**N6776A-01**

**S E R V I C E N O T E**

**N6776A 300W DC Power Module**

**Current Measurement accuracy is out of specification when there is voltage being sourced at the output terminals.**

Location of C36 and C37

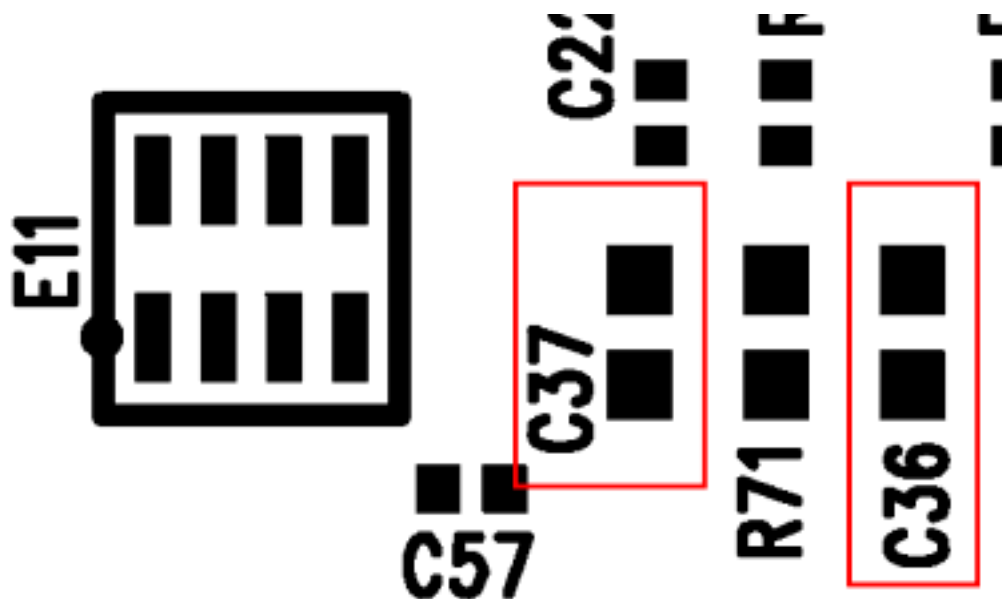
Due to some noise filtering issues, the current measurement accuracy will be out of specification by a fixed offset when there is a voltage being sourced at the output terminals. If the output is shorted, the current measurement accuracy will be within specifications. Please note that the performance verification test will not catch this.

If this measurement is out of specification, replace capacitors C36 and C37 on the DPM assembly (this is the assembly that is vertically mounted in the unit that looks similar to a PC memory module) with part number 0160-7809. After the capacitors are changed, the unit will require re-calibration. After the capacitors are replaced, check the make sure that the unit is in specification by applying 75% of the full voltage range while attached to a load drawing 50 mA to 70 mA. If the current measurement is within the specification, then the unit has been repaired.

Test to see if the module is out of specification by applying 75% of full scale voltage while drawing 50 to 70 mA . Compare the reading to what it should be via the current measurement accuracy spec. If the current measurement is within specification then the capacitors will not need to be changed.
